4/23/03	Revised 6'x4' Culvert Extension Per Change Order
DATE	REVISION
STATE OF HAWAII DEPARTMENT OF TRANSPORTATION HIGHWAYS DIVISION DRAINAGE PLAN - 1 KAMEHAMEHA HIGHWAY RESURFACING Waiahole Valley Road to Crouching Lion Inn Federal Aid Project No. NH-083-1(43)	
Scale: 1" = 10'	Date: August 1, 2000
SHEET No. C-27 OF 65 SHEETS

KAMEHAMEHA HIGHWAY RESURFACING
Waiahole Valley Road to Crouching Lion Inn
Federal Aid Project No. NH-083-1(43)

FED. ROAD DIST. NO.	STATE	FED. AID PROJ. NO.	FISCAL YEAR	SHEET NO.	TOTAL SHEETS
HAWAII	HAW.	NH-083-1(43)	2001	C.O.34S-1	121

SECTION C

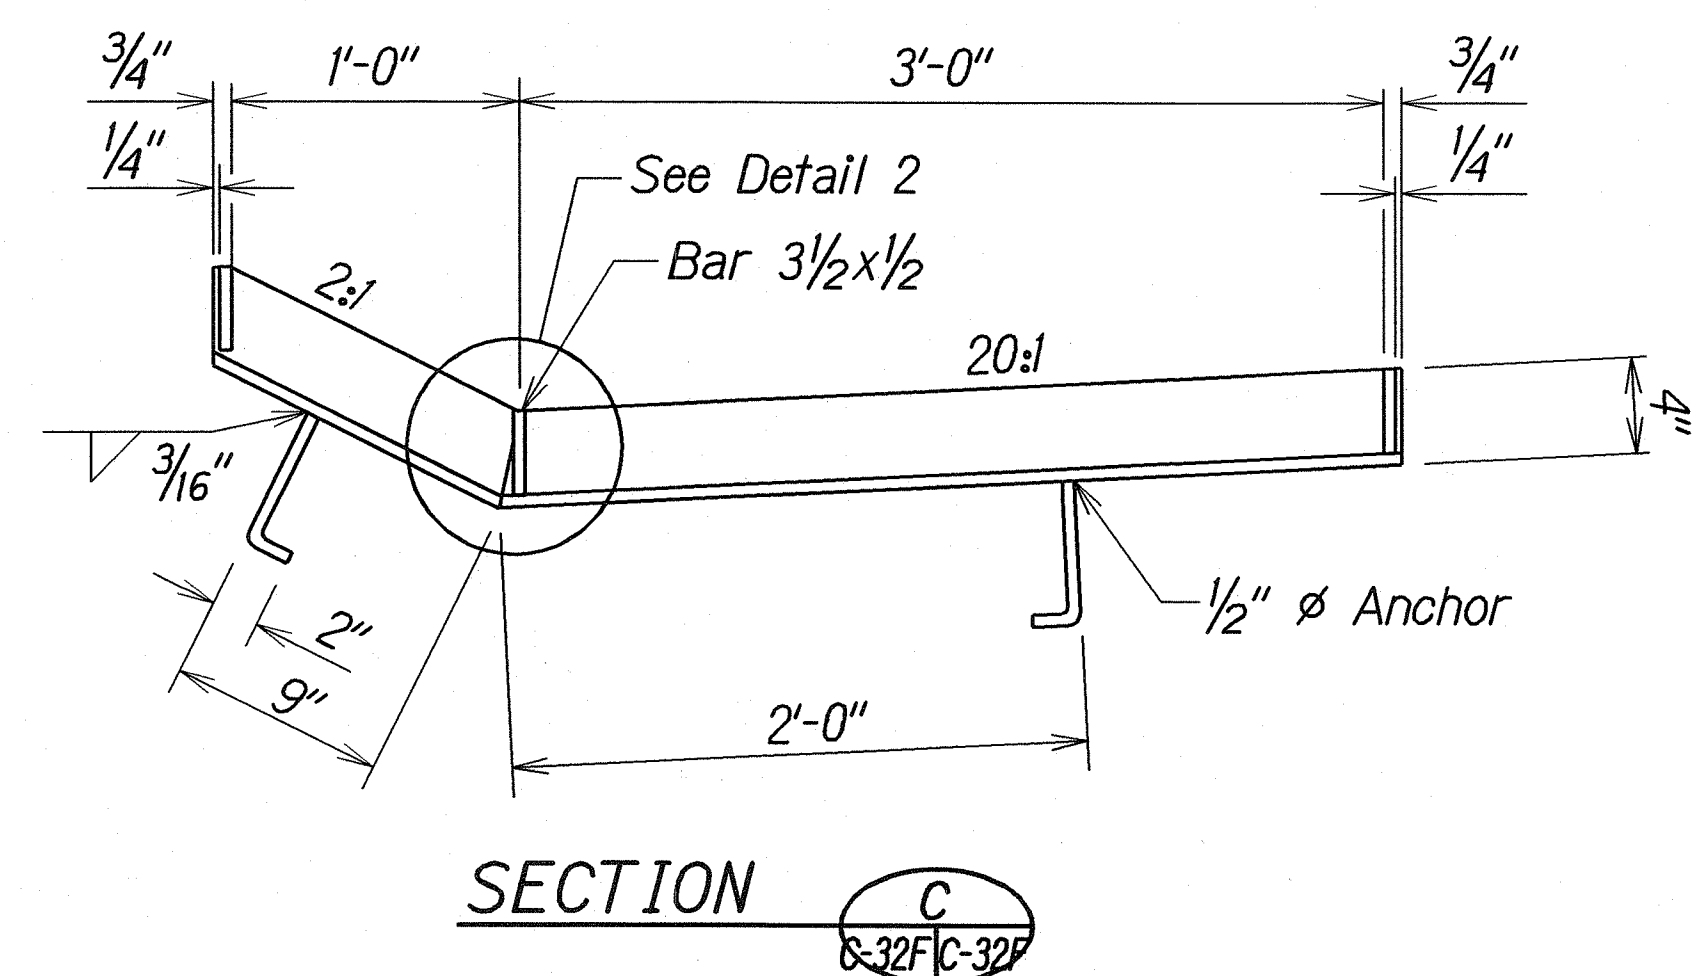
9/3/02	Add drainage detail of Type 201214P Frame and Grates.
DATE	REVISION
STATE OF HAWAII DEPARTMENT OF TRANSPORTATION HIGHWAYS DIVISION	
DRAINAGE DETAILS	
KAMEHAMEHA HIGHWAY RESURFACING Waiahole Valley Road to Crouching Lion Inn Federal Aid Project No. NH-083-1(43)	
Scale: As Shown	Date: April 2002
SHEET No.C-32F OF 74 SHEETS

UTILITY PLAN

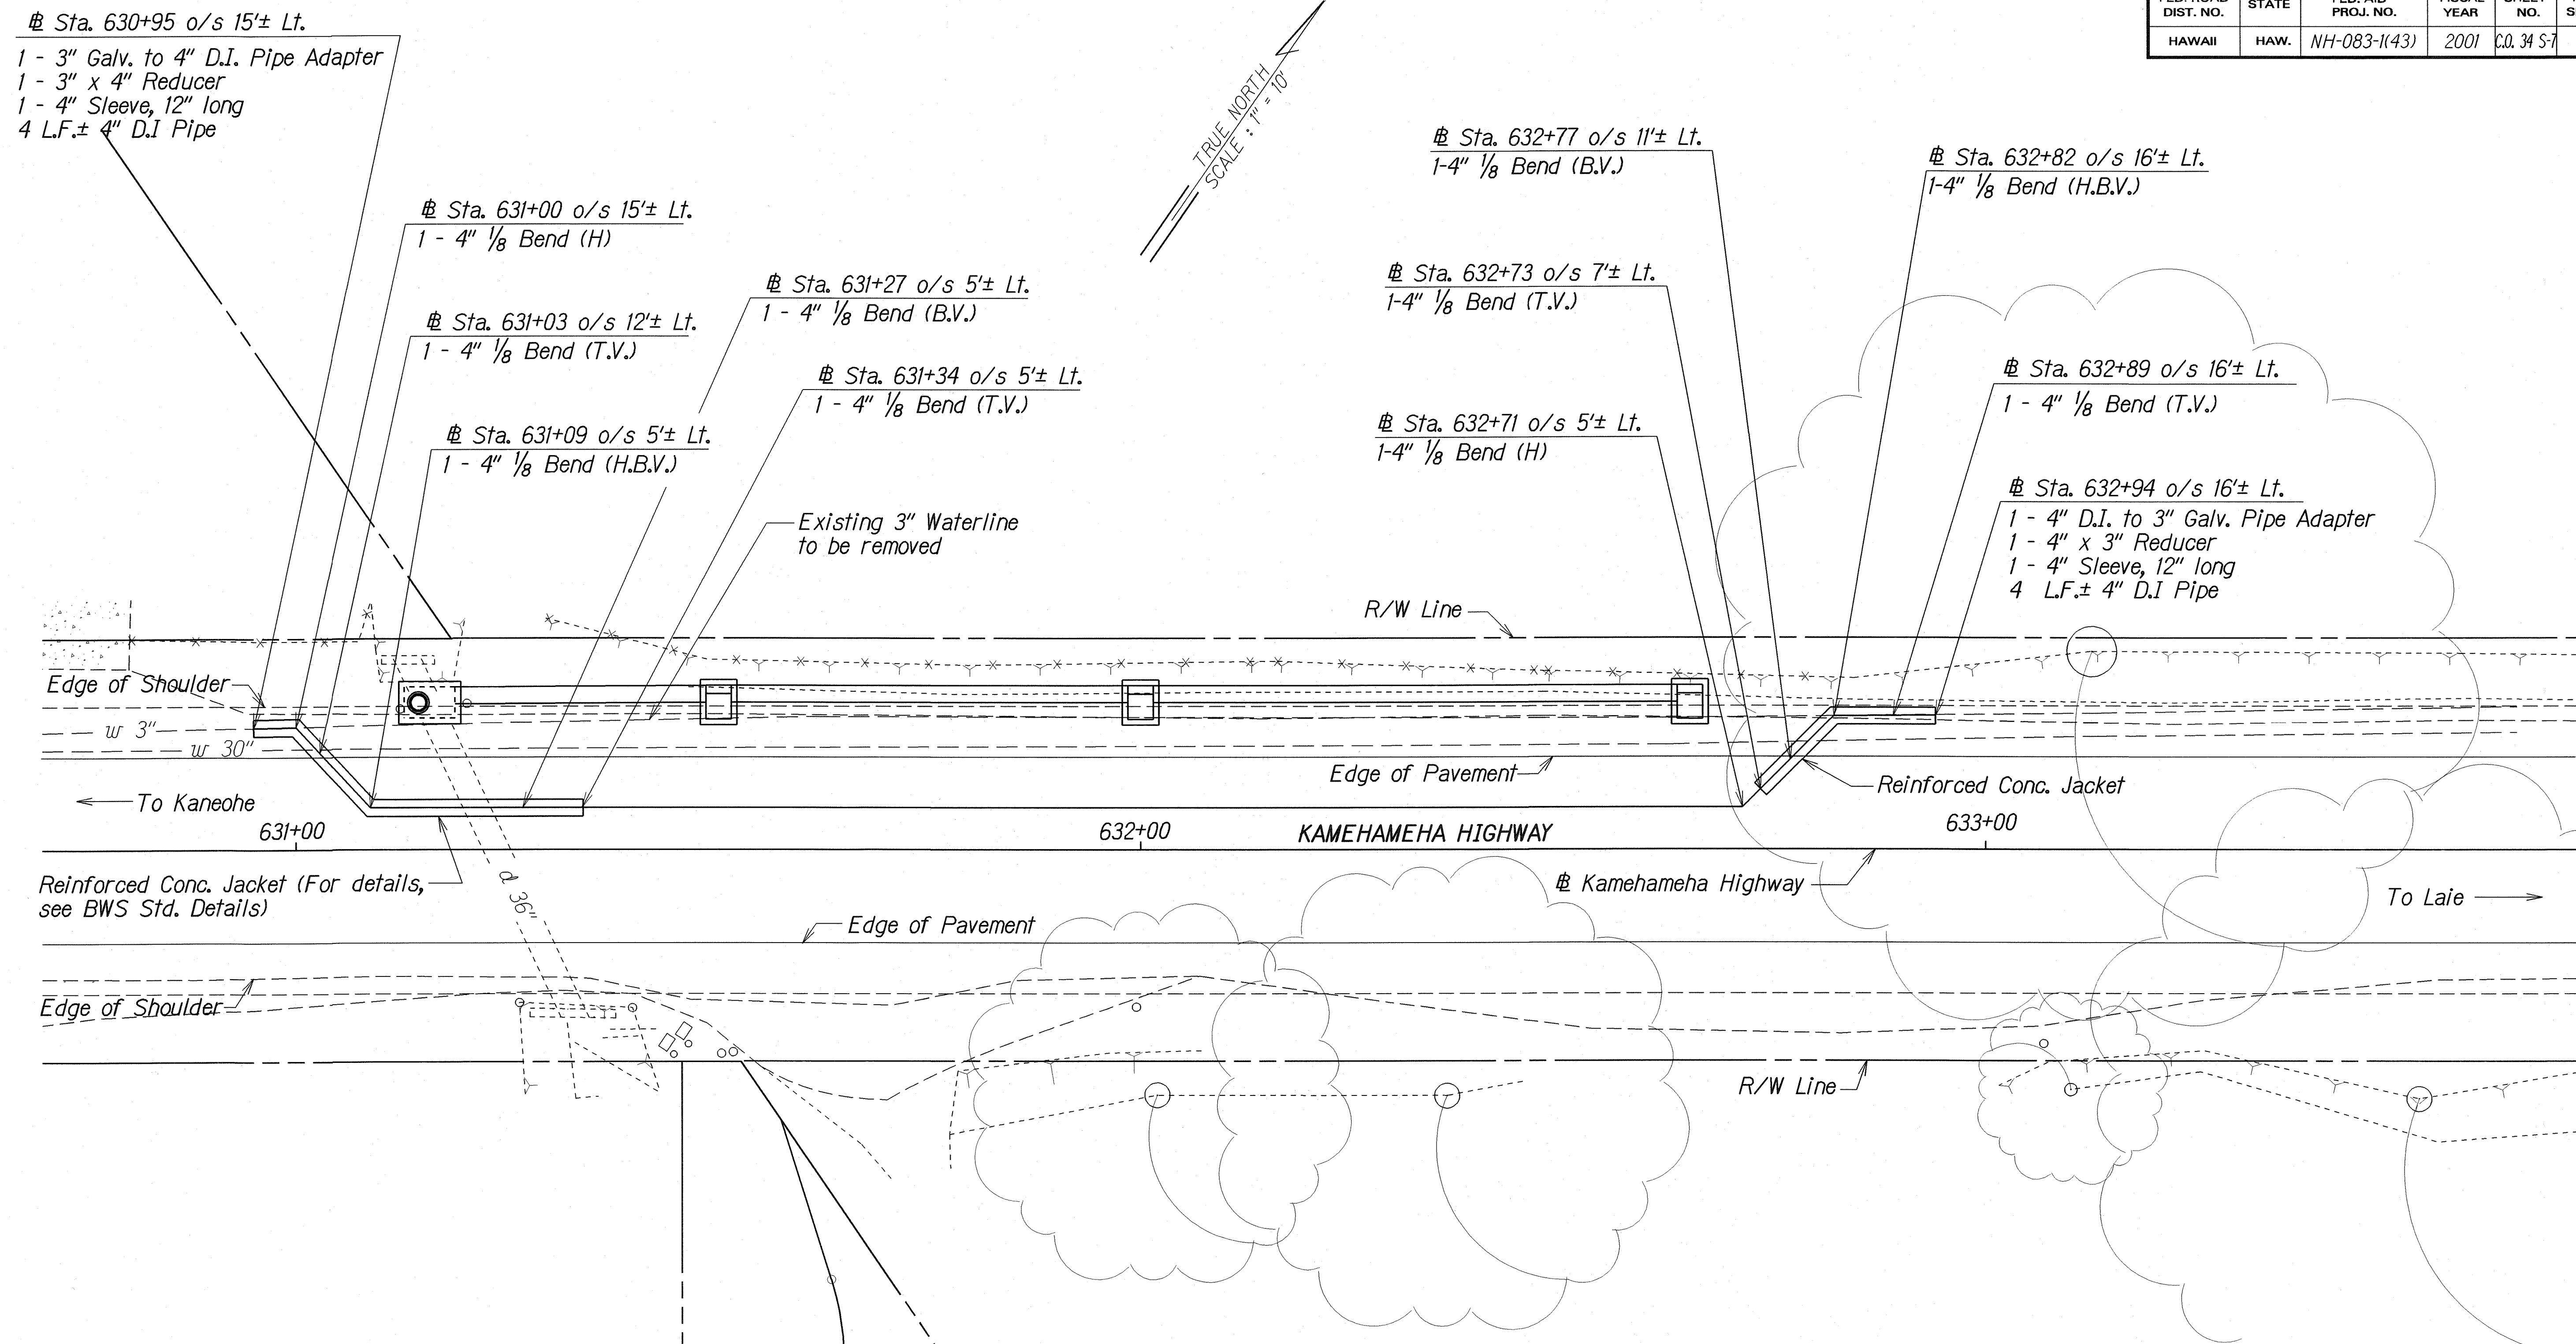
9/3/02	Add utility plan for water line relocation.
DATE	REVISION

PROFILE - WATERLINE ADJUSTMENT AT @ STA. 631+00 to @ STA. 632+82

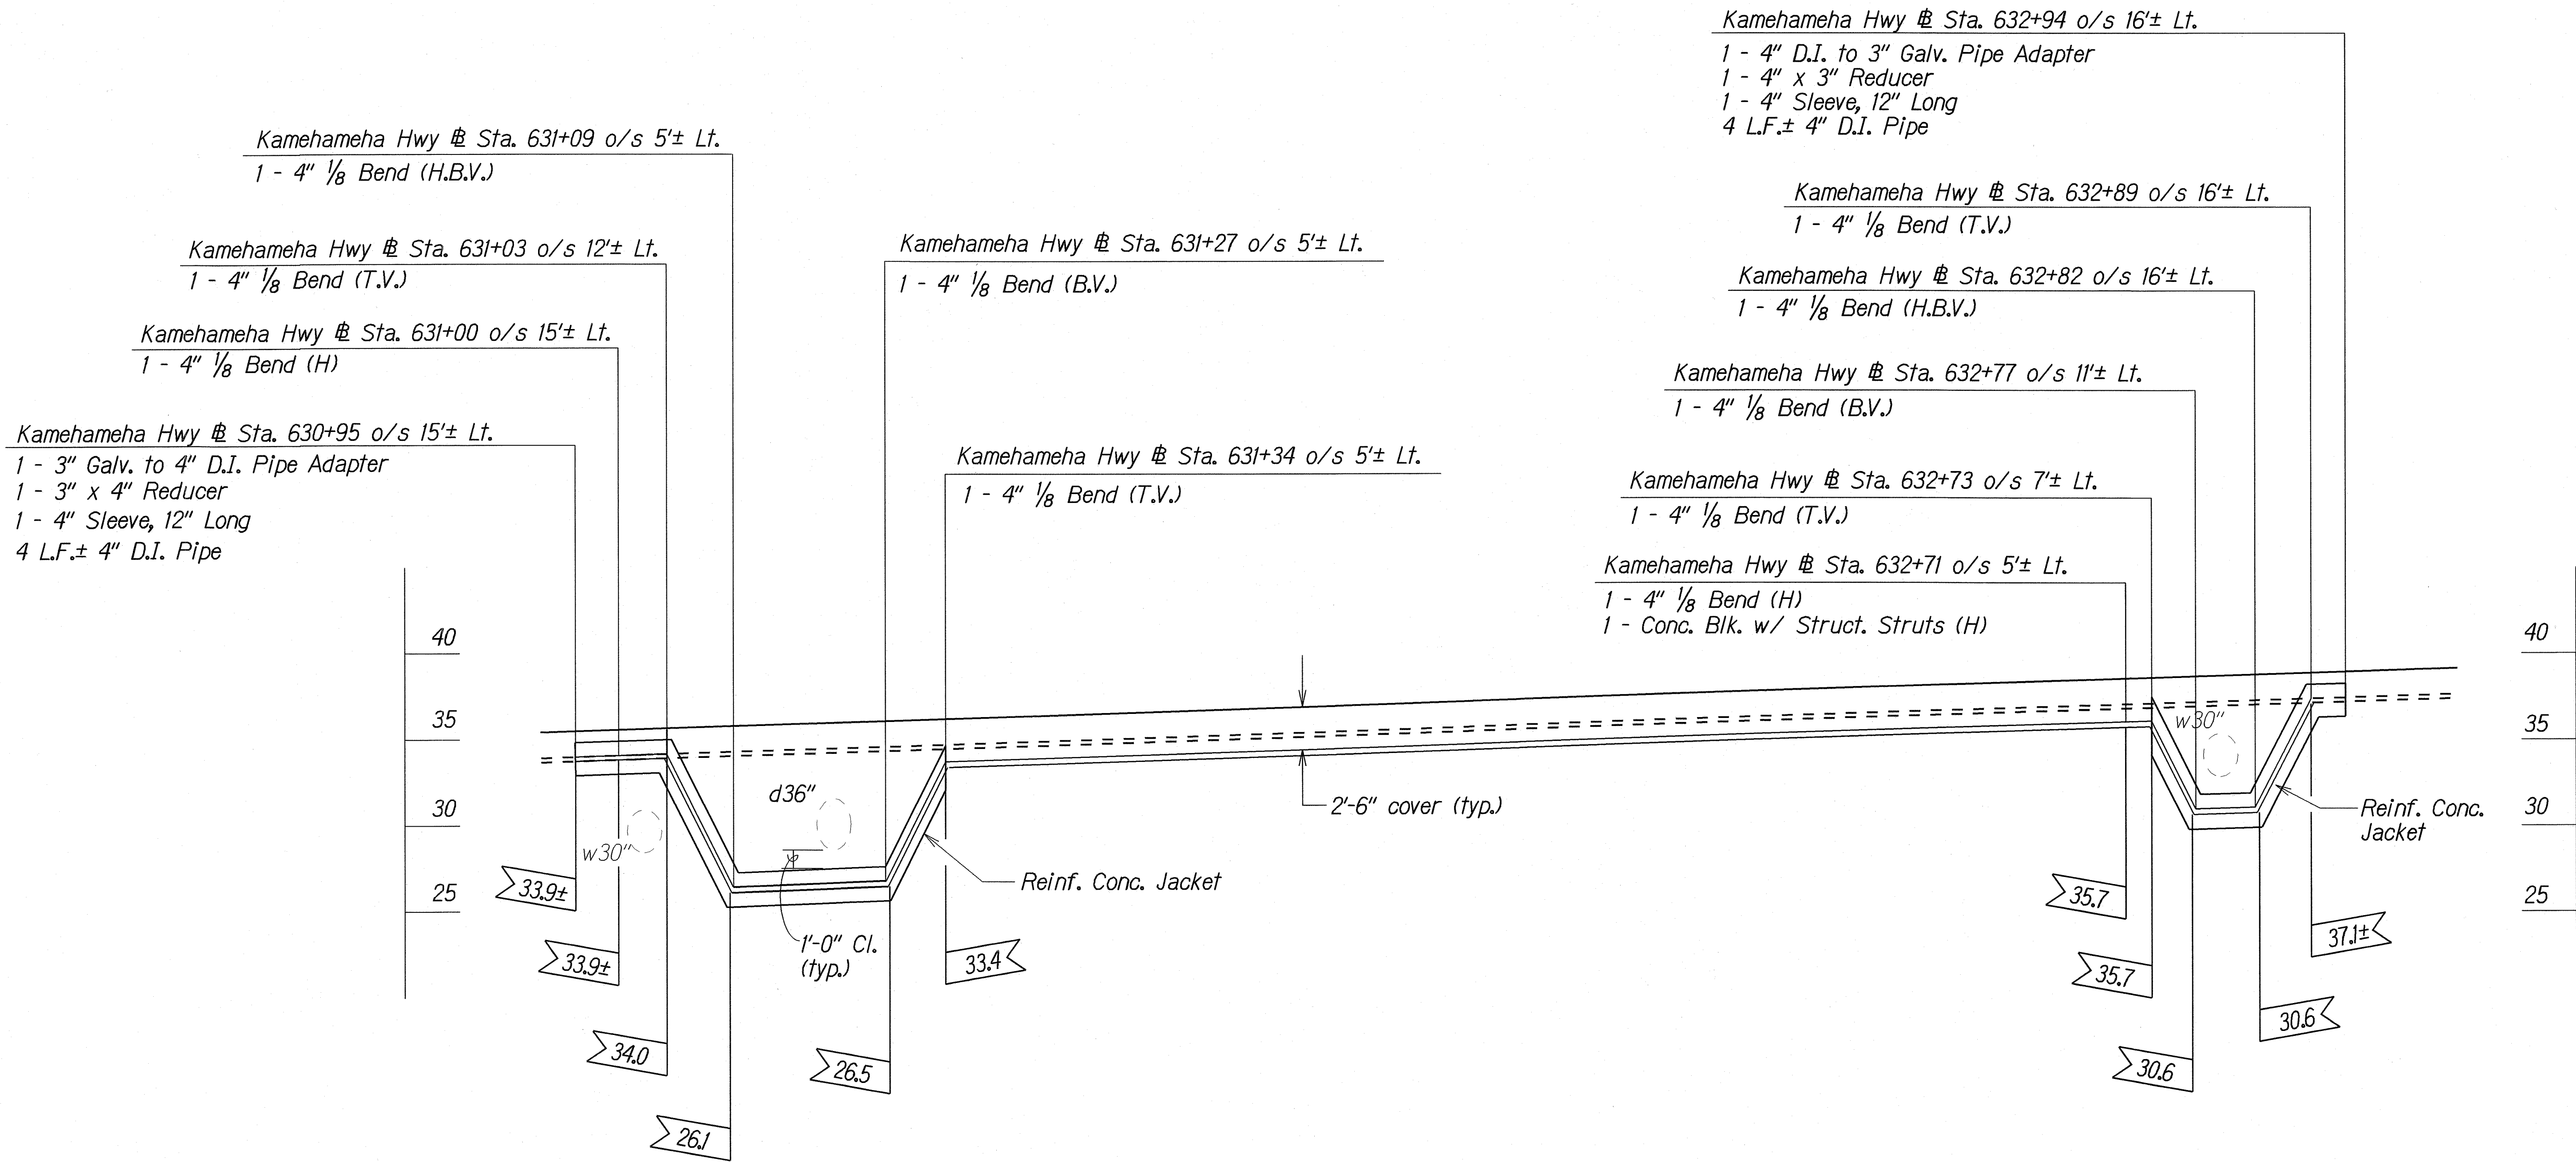
9/3/02 Add waterline adjustment details showing water line relocation profile.
